**ADDENDUM
NO. 2**

**VALPARAISO COMMUNITY SCHOOLS - DISTRICT PLAYGROUNDS
RENOVATIONS**

ADDENDUM TWO

Addendum Two (AD.02) to the drawings and specifications prepared by Gibraltar Design for **Valparaiso Community Schools - District Playgrounds Renovations** for Valparaiso Community Schools, Valparaiso, Indiana.

2. Sheets C-1.0 and C-2.0

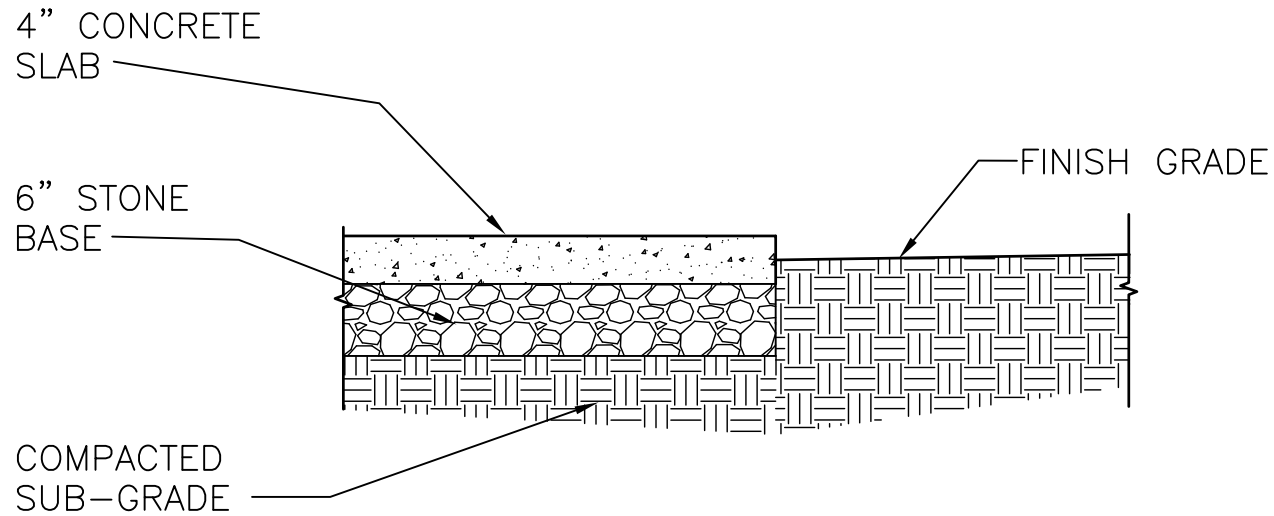
A. Graphic Scale indicated on the Drawings should be 1 1/2" = 20'.

CONCRETE SLAB SIDEWALK DETAIL

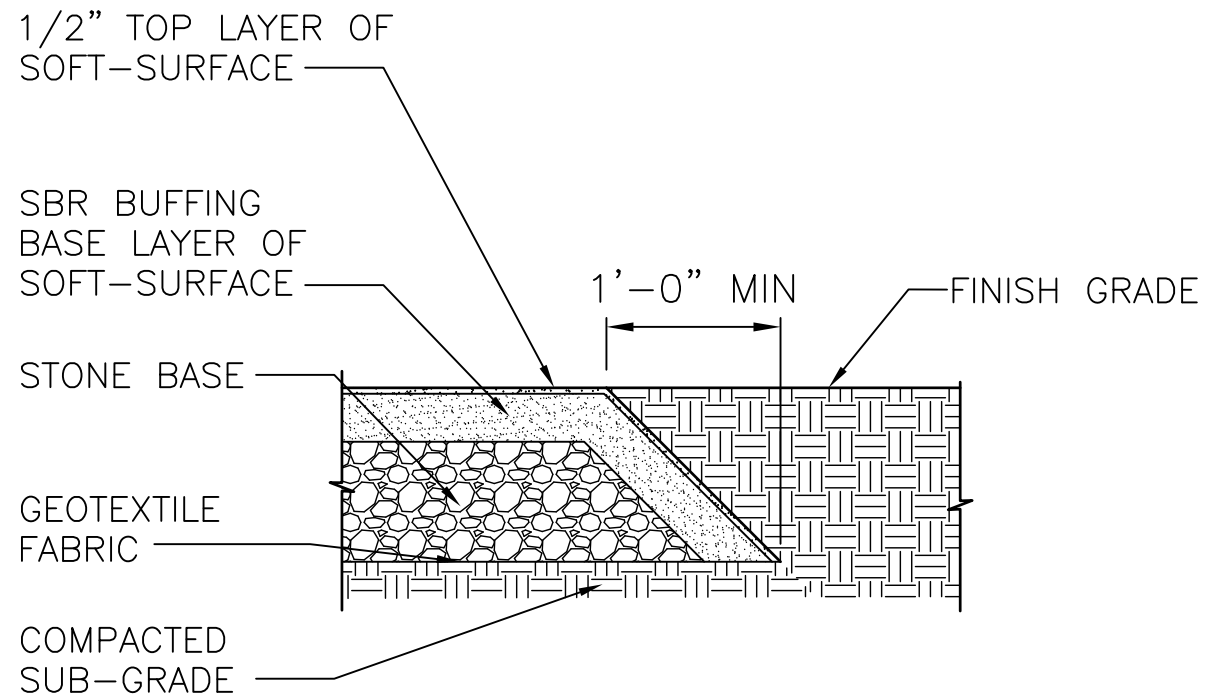
- A. Sheet C-301 will be issued in the Construction Set, however, there are three details included in this Addendum that are included on that new Sheet.
- B. See Detail 1/C-301, included with this Addendum, for the Detail of the Concrete Sidewalk.
- C. See Detail 2/C-301, included with this addendum, for the rolled edge along the soft-play playgrounds – that is to be coordinated with the Soft Surface Contractor. Note that the alignment and termination along asphalt edges is similar to Detail 3/C-301.
- D. See Detail 3/C-301. Included with this addendum, for the trench drain set in concrete and site transition detail. Note: Contractor is responsible for determining the final inverts for the trench drain based on filed conditions and select the specific trench drain for slope that is required.
